TO: CEO Michael Thurmond, Dekalb County
ATTN TO: Larry Washington, Planning Administrator, Dekalb County
FROM: Mike Alexander, Director, ARC Center for Livable Communities
RE: Development of Regional Impact (DRI) Review

Name of Proposal: Apex Audubon DRI 3783

Description: A DRI review of a proposal to construct 775 residential units and 20,000 SF of retail space on a 7.24-acre site located in unincorporated DeKalb County off of Woodcock Boulevard at the I-85/Chamblee Tucker Road interchange.

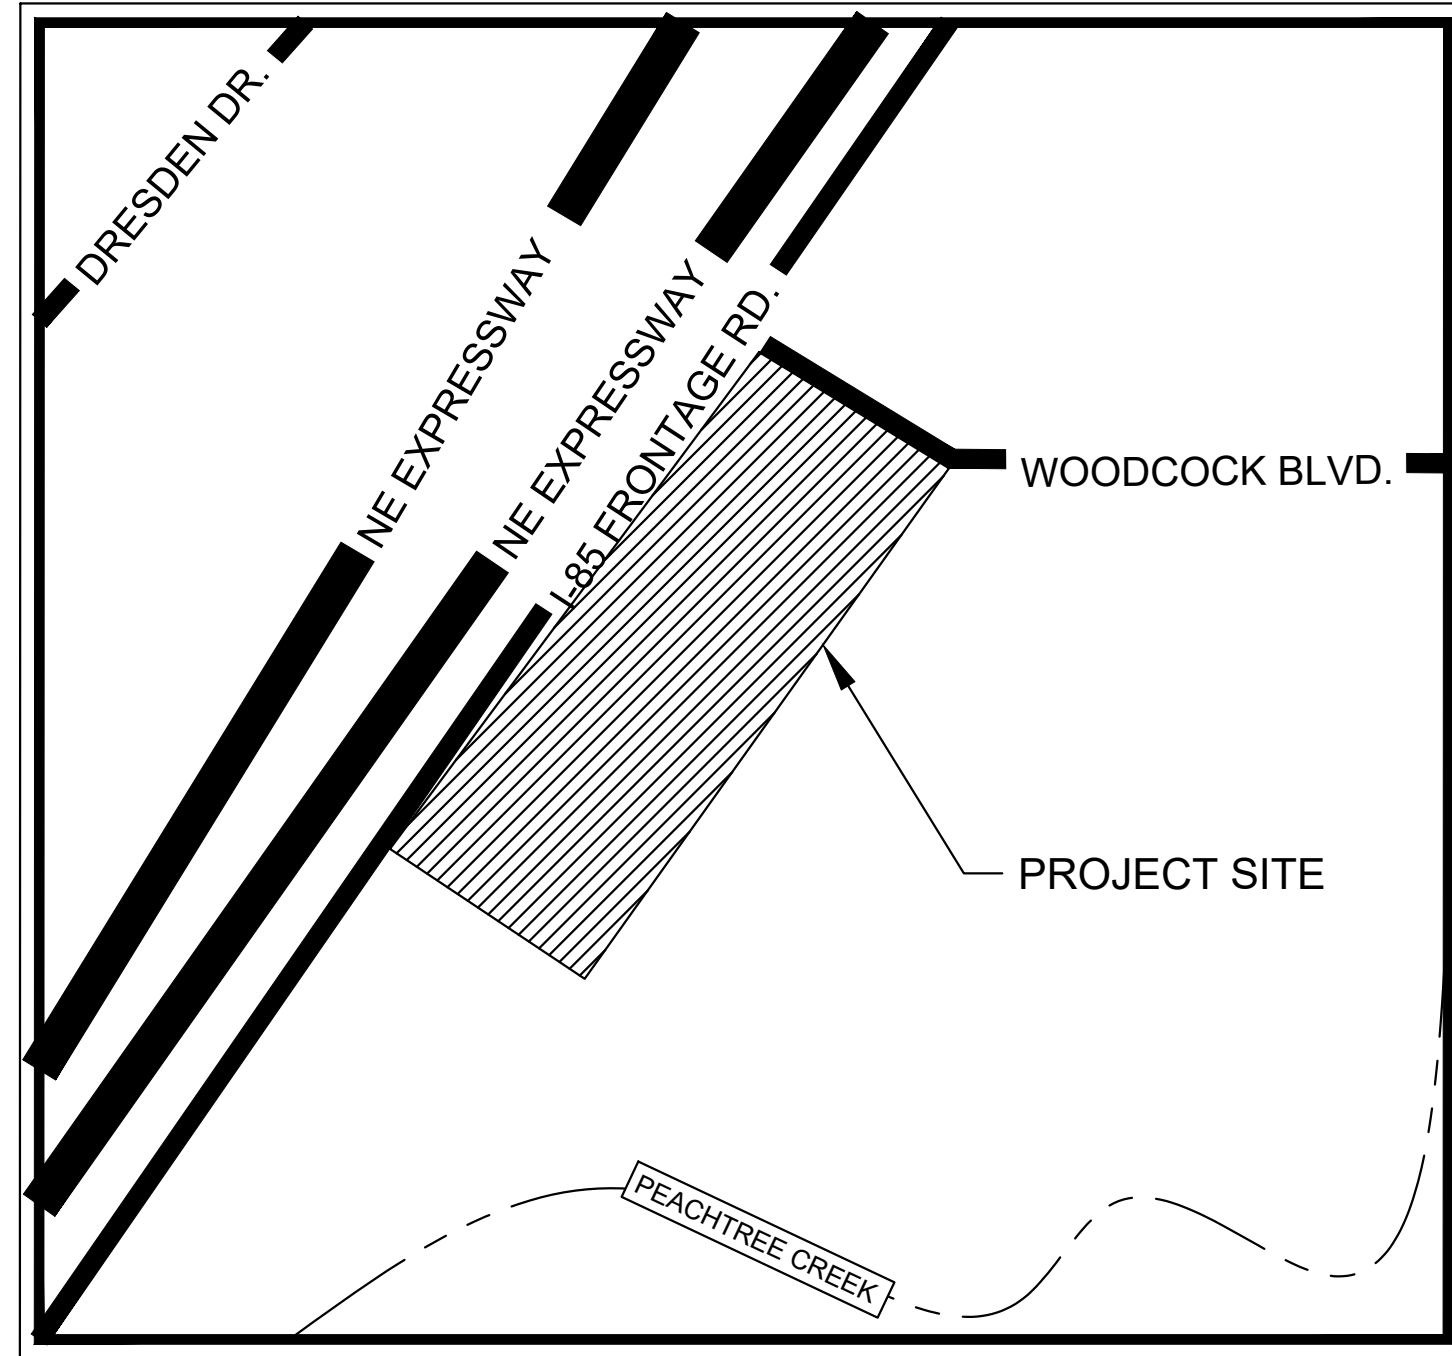
My only comments was that I think there should be more crosswalks on the rear drive, especially near connection to the PCG. It doesn't appear there is a proposed sidewalk on the other side of the rear drive, which may be by design, and the only place to cross is to the observation deck. But the PCG connection itself looks like it is larger than just the observation deck, so people exiting the building will likely just cross immediately if they are going to the PCG (red lines below). In addition, the corners of the building appear to have points of ingress and egress, so somebody coming or going those directions is likely also going to use the most direct route (blue lines).
